KUDZ ZE KAYAH PROJECT

RESPONSE #3 TO YESAB EXECUTIVE COMMITTEE INFORMATION REQUEST KZK

June 2018

TITLE:
**FIGURE 10-1
LNG FACILITY
OVERALL SITE PLAN**

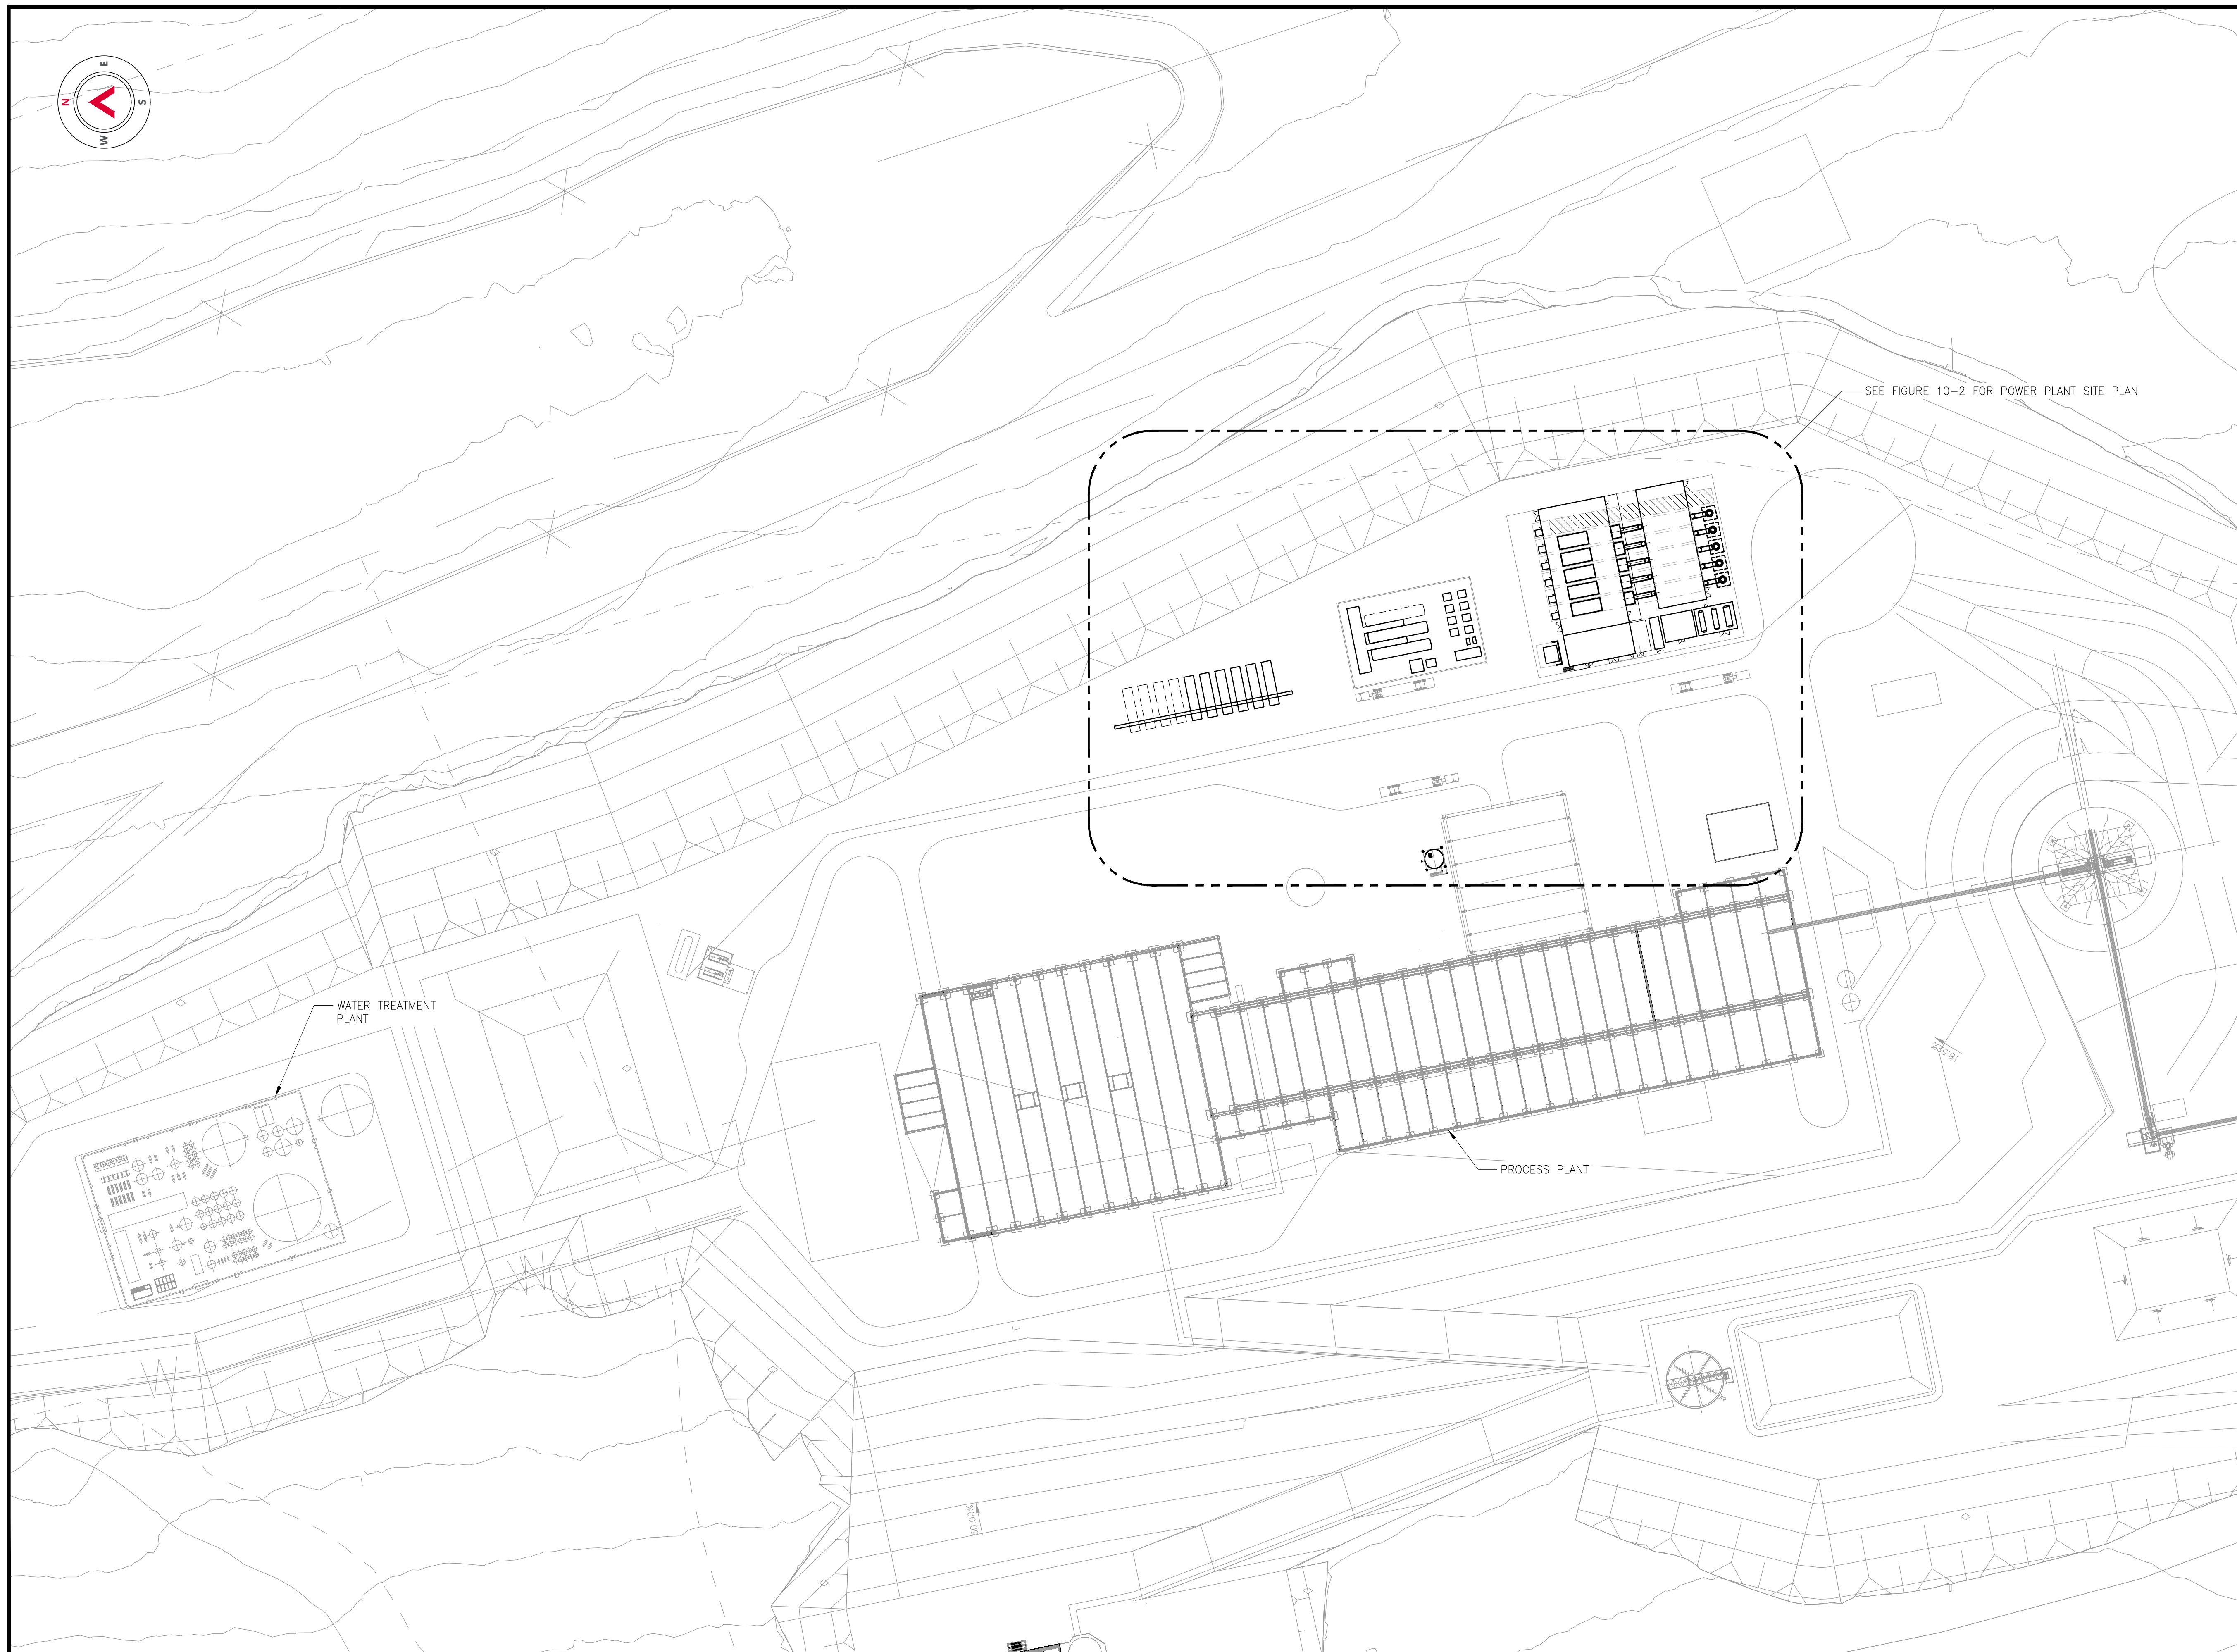
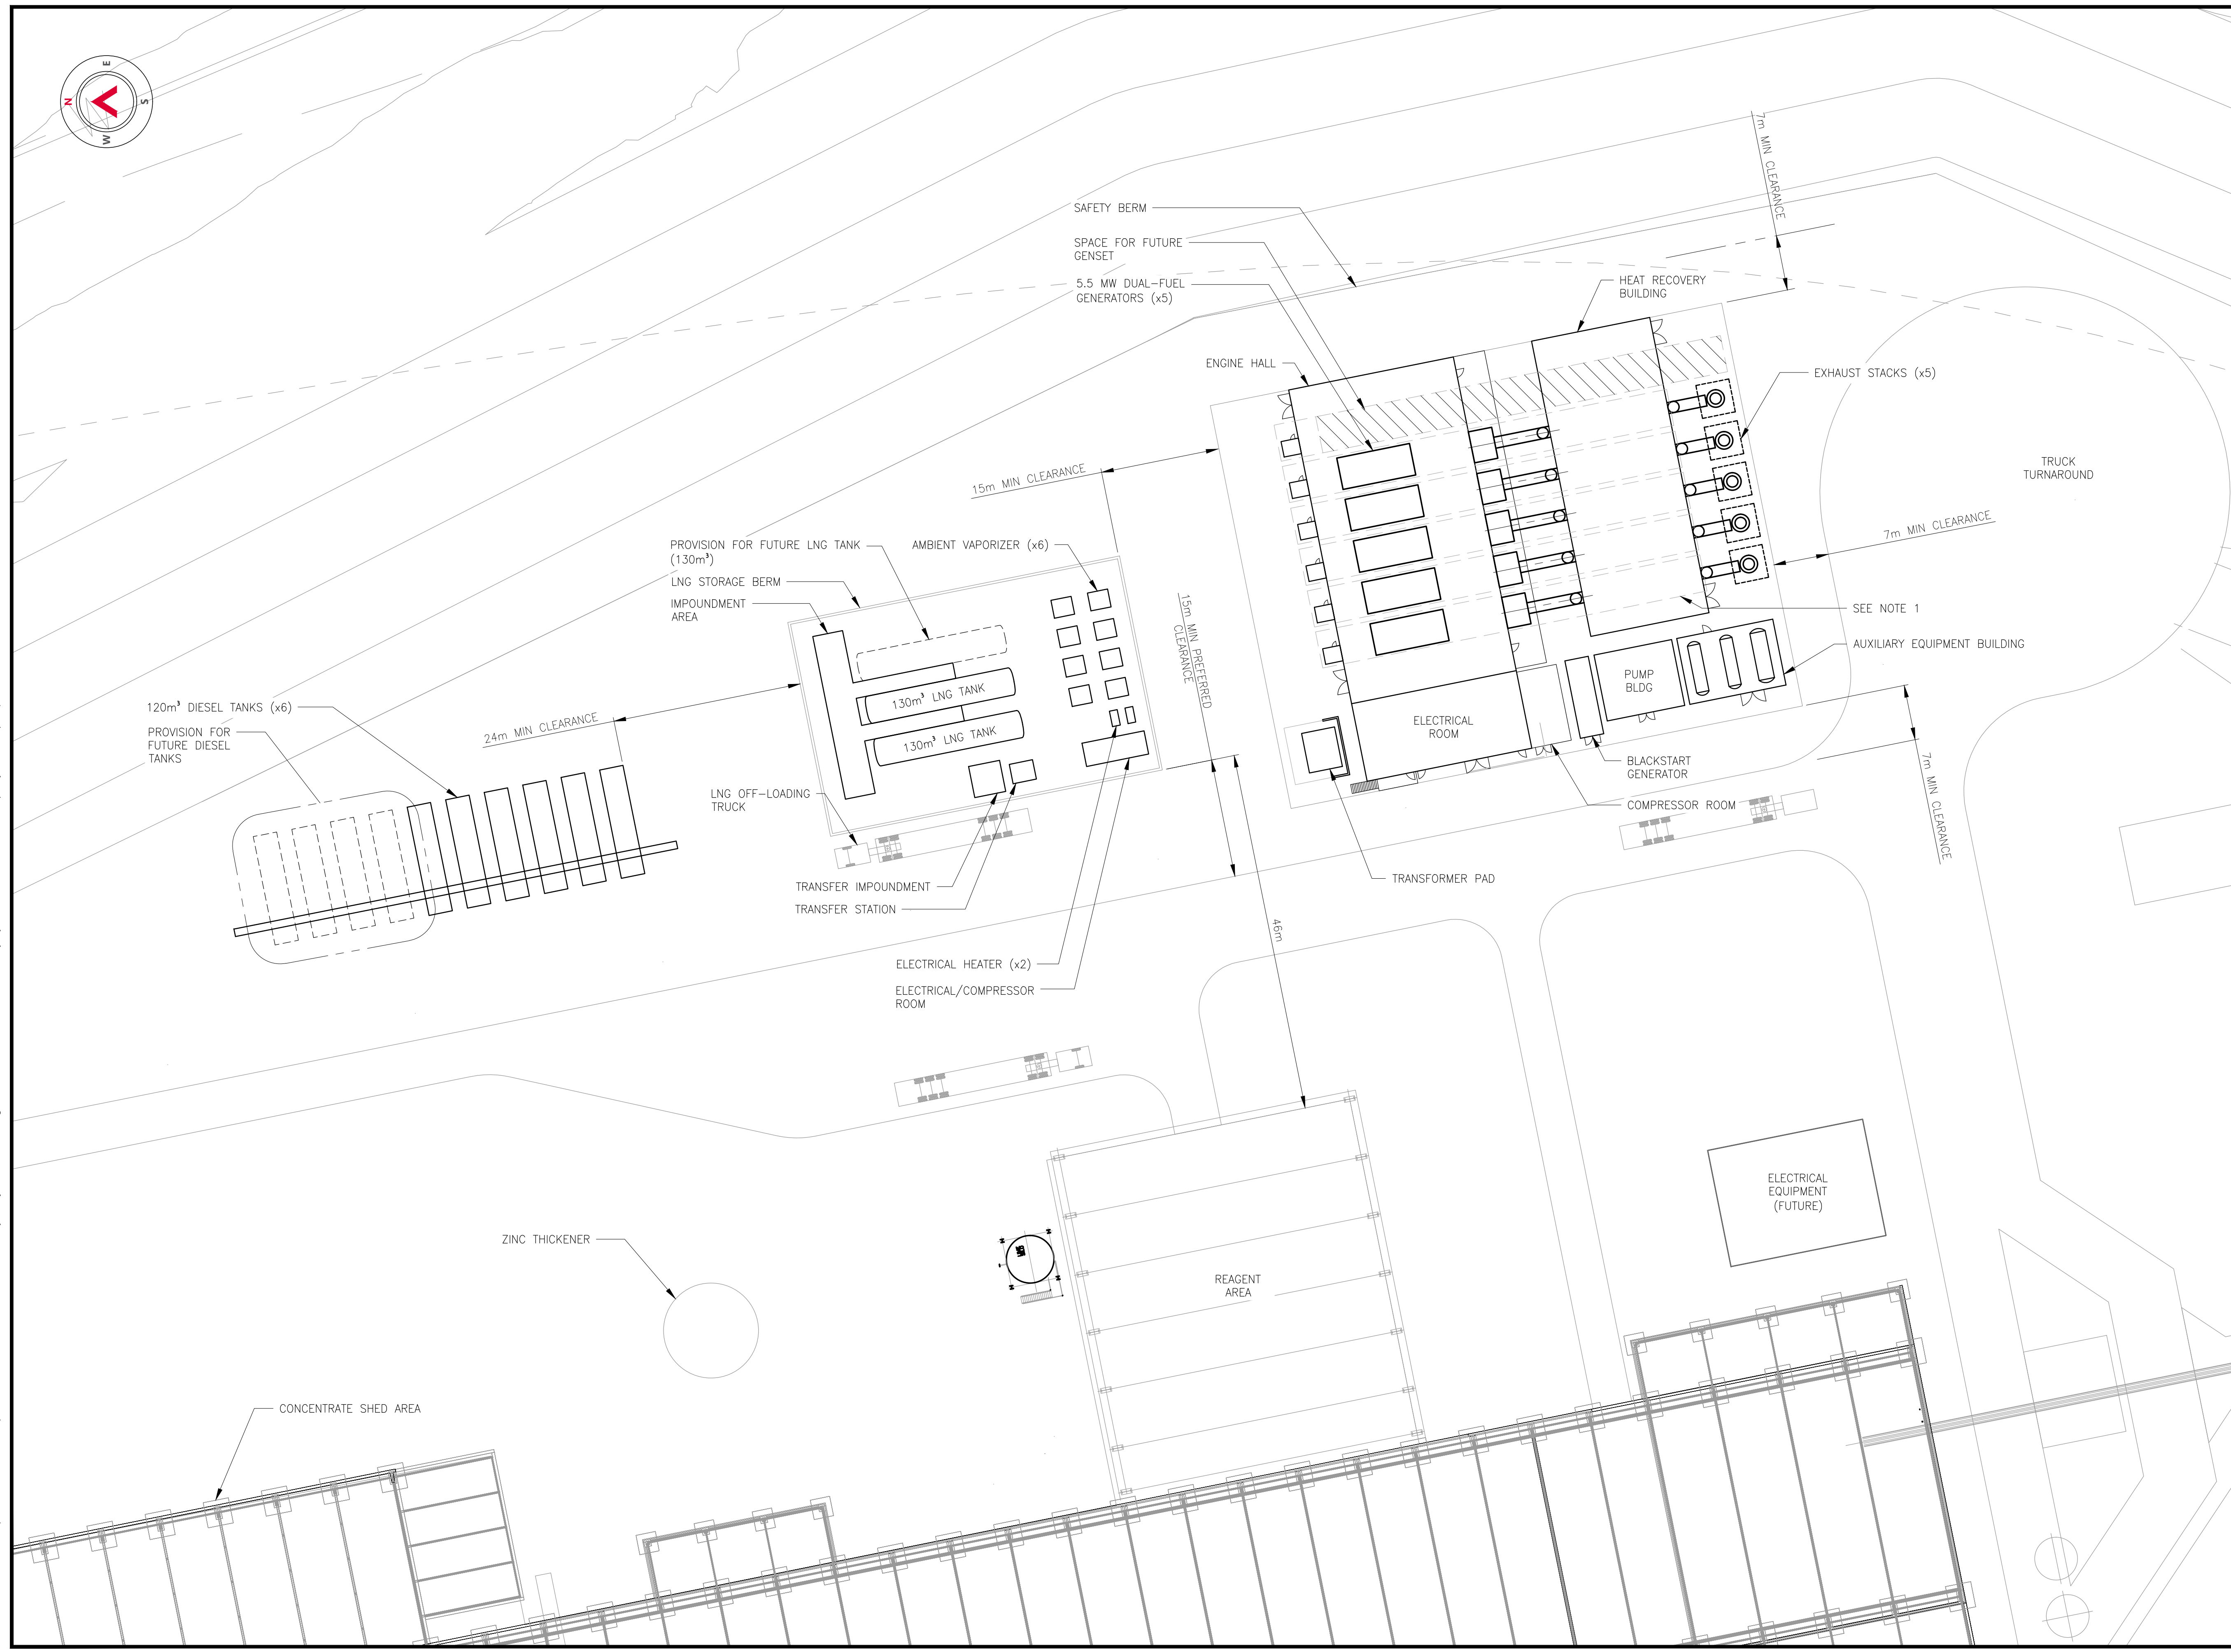
These distances described above been built into the layout detailed in Figure 10-1: LNG Facility Overall Site Plan and Figure 10-2: LNG Facility Layout with Offsets.
